RE: BZA #20382, Joint Parties in Opposition Revised Motion to Strike Misleading Information

II. Exhibit 70, strike or correct C-6, D-1, A-1, A-4, A-5, A-6, D-1, because they conceal unlawful construction, conceal the future scope of construction, buttress the misleading information provided to other District officials, and impair an accurate review.

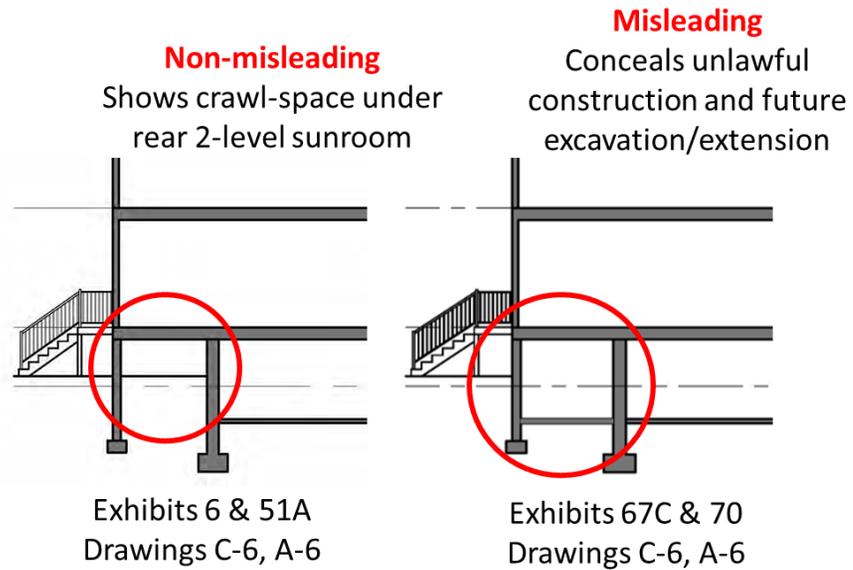
The annotations of the drawings included below show *how* the drawings are misleading, and the explanations below describe *why* the misleading drawings are materially prejudicial.

Exhibit 70 D-1, A-1
Main Floor

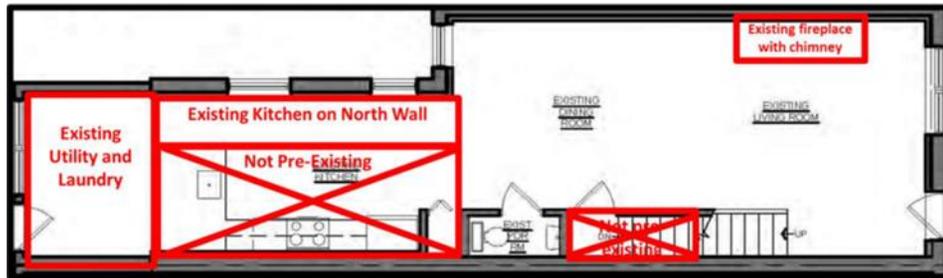
- **Strike or correct Drawings D-1, A-1 because they conceal the scope of construction and impair accurate review.** (NOTE: overlays NTS but are best efforts.) The Applicant misleadingly portrays other elements of the interior of the main building as “existing” that never have existed or do not exist as depicted, including the exterior façade, the eat-in kitchen on the main level, and the entire second level layout. These misleading drawings are nearly identical to the falsely portrayed floor plans for existing permit B2007169, which impact an accurate review of application B2100790. **These misleading drawings cover up the Applicant’s stated intent, in July 2020, to tear down and replace the existing 2-level rear addition, potentially damaging the adjoining property, removing a fire barrier, and avoiding the neighbor notification process** (emails from Applicant July 2020):

V. Accuracy of Building Height and “Cellar” Designation for “by right” Rooftop Pop-up

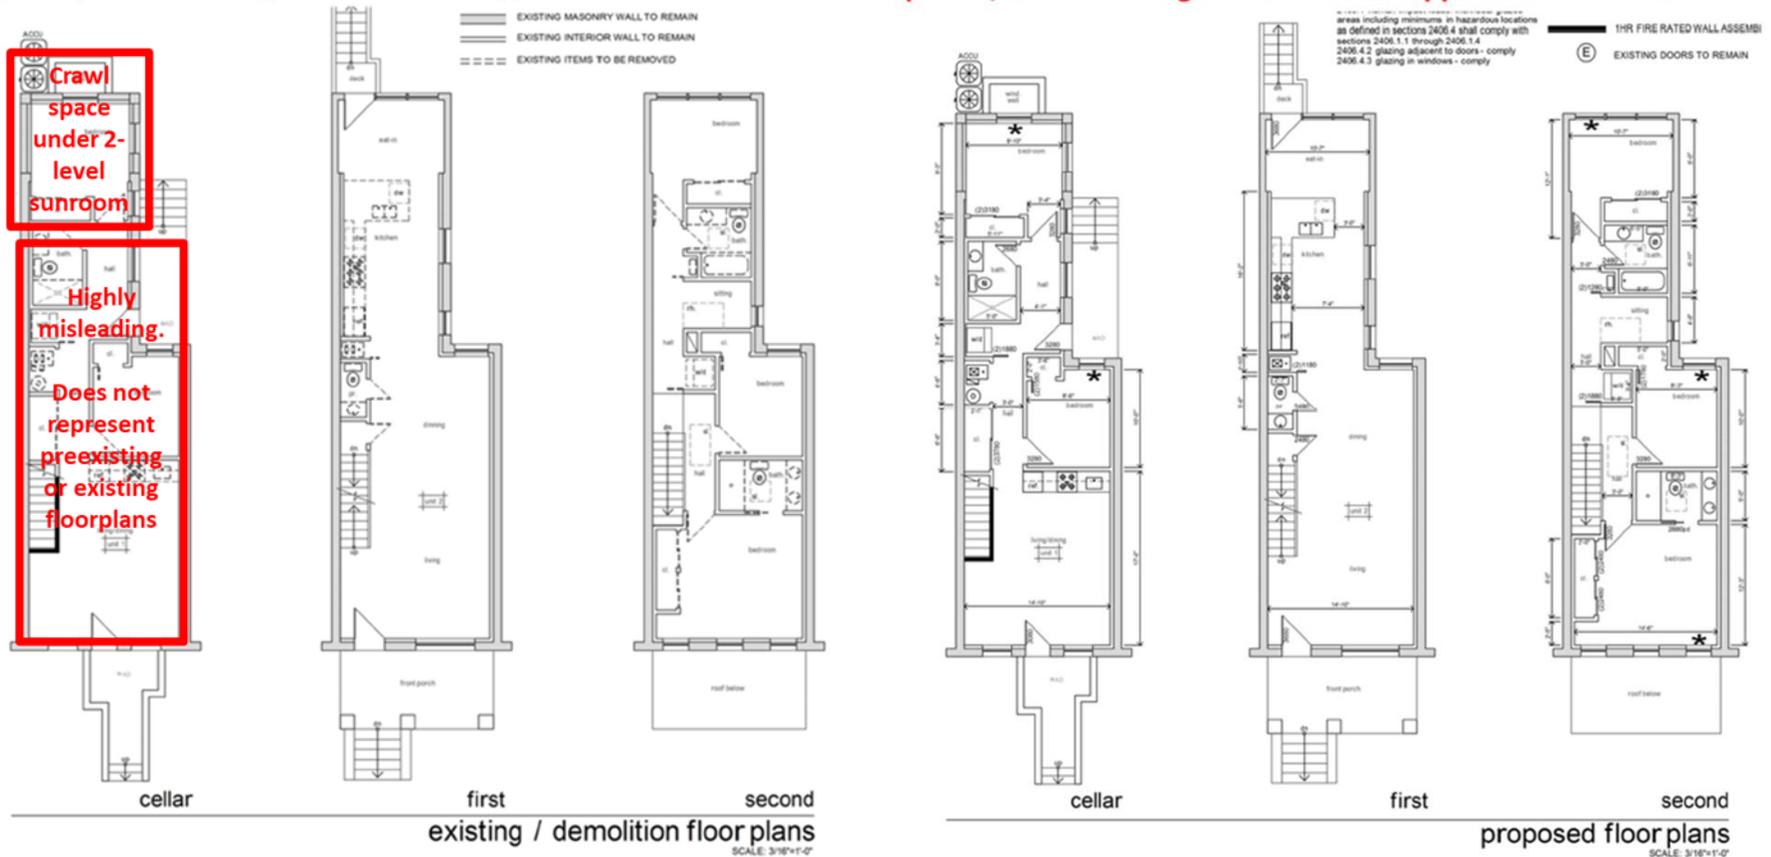
In light of the Applicant’s pattern of providing materially misleading information in this case (e.g., concealing lot occupancy, concealing unlawful construction, etc.), we question the Applicant’s own determination that the lowest level of the property is a “cellar” rather than a basement.

building's Building Height Measuring Point, the height from the finished adjacent grade to the finished main floor is 4' 11", one inch shy of the lowest level being a basement. The Applicant's own filings show in multiple submissions he was over 70% lot occupancy. Given the Applicant's history, the precedent-setting of the rooftop pop-up in our neighborhood, and the strong neighborhood opposition, we think it is reasonable to request the Applicant to provide a **registered survey** confirming this height measurement. We have reviewed the Applicant's opinion from the Zoning Administrator and have identified gaps, but are unable to appeal it until a permit is issued because it is not considered final agency action.
